Subject- New Lamprey ¾” Grating Criteria Implementation Recommendation

Purpose- In July of 2007, new NMFS lamprey criteria was provided for diffuser gratings requiring ¾”. Up until that point, there were no criteria available. This change affects gratings with associated trash racks on ladders on the Columbia River.

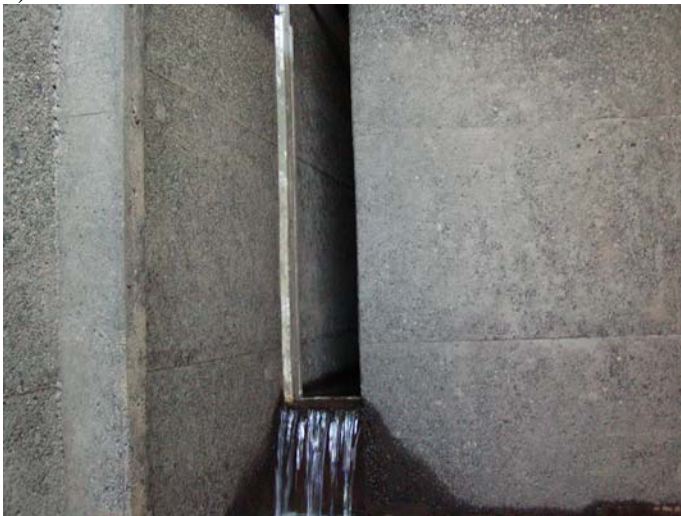
- 6) **Exit stub wall** – 6” raise in floor under road deck located at half duplex antennae. Option; ramp. Picture below.
